1 The Avenue is a shared Freehold of three flats, I am one of the freeholders of this property. [REDACTED]. Permission for these works was neither sought nor given. **The leasehold of 1 A The Avenue states clearly that use of the garden is exclusive but that it must be kept ' in a proper state of cultivation'.**

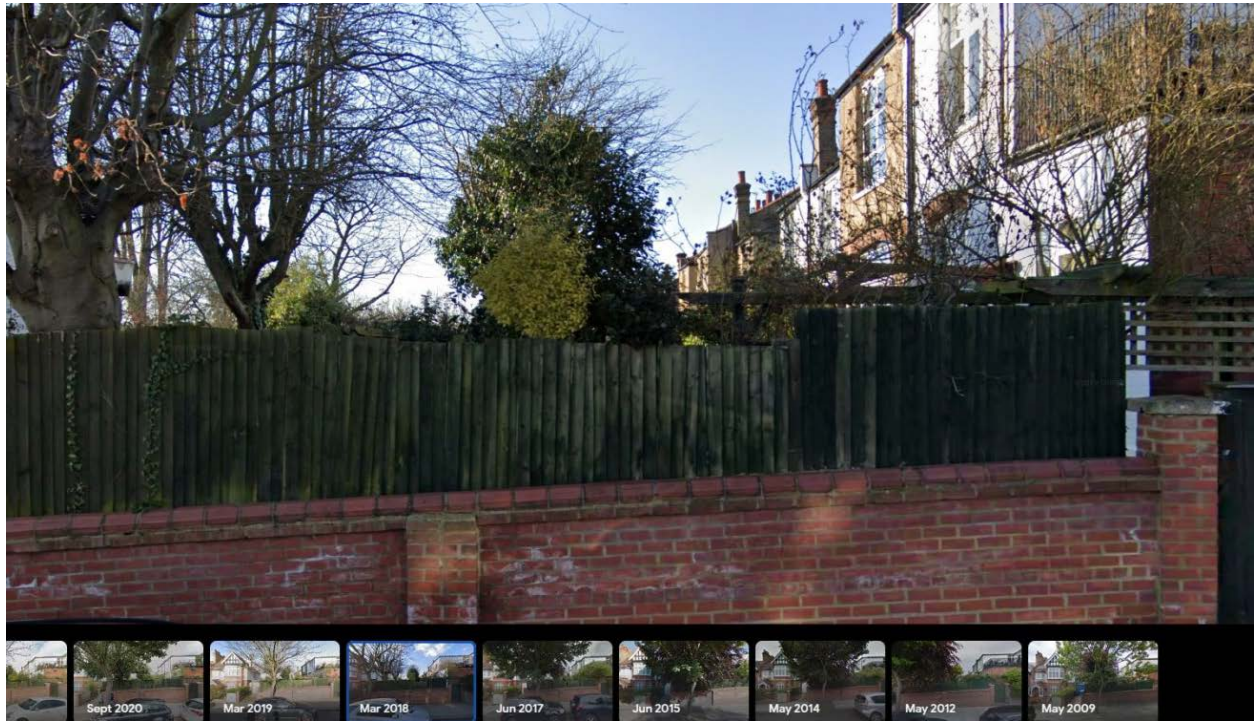
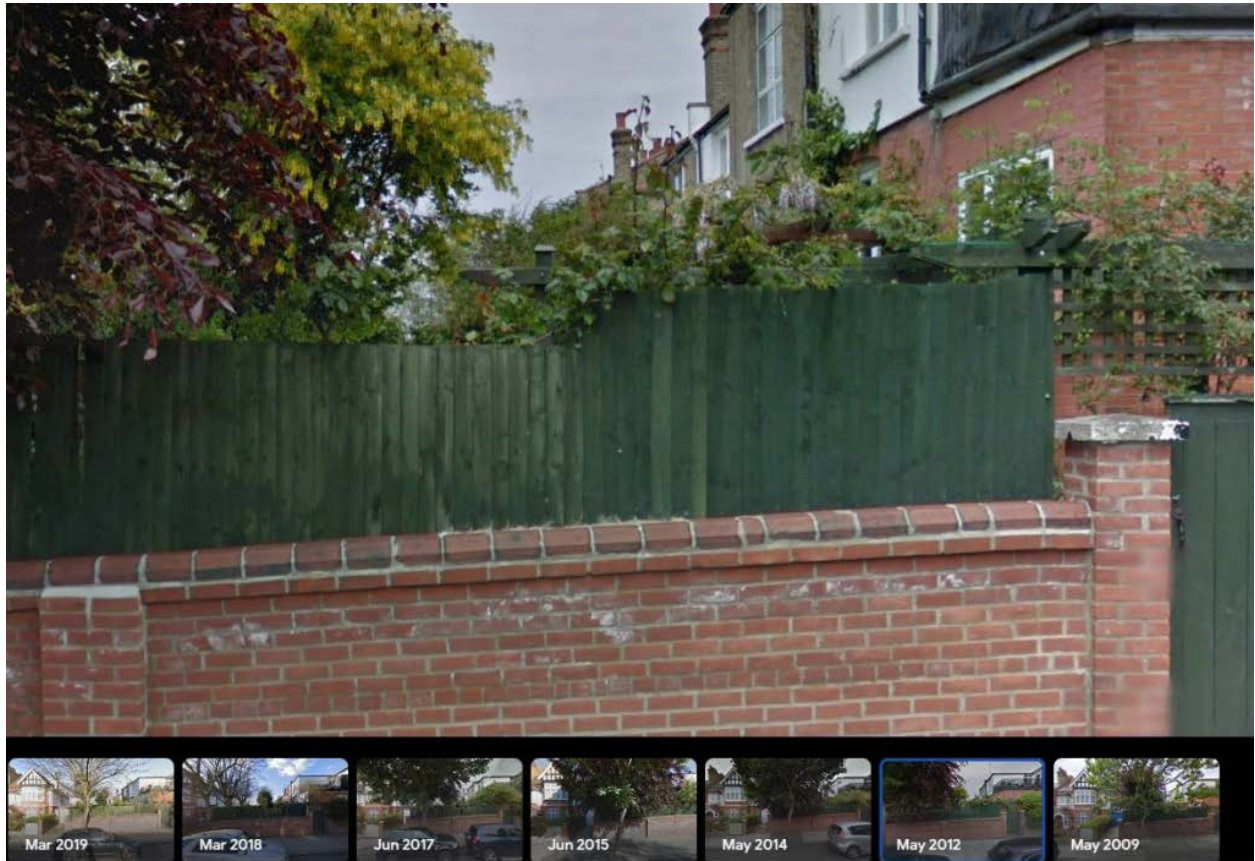
There is already visible water damage on the garden level of the boundary wall.

There is no water damage. The soil levels have always been high in the garden due to its location at the top of the hill and how quickly it slopes down, that has always caused some degree of white marks on the wall.

All of this can clearly be seen in the images in the planning app which also show the wall over time.

From prior to the rebuild of the wall:

From 2018:

From 2012:
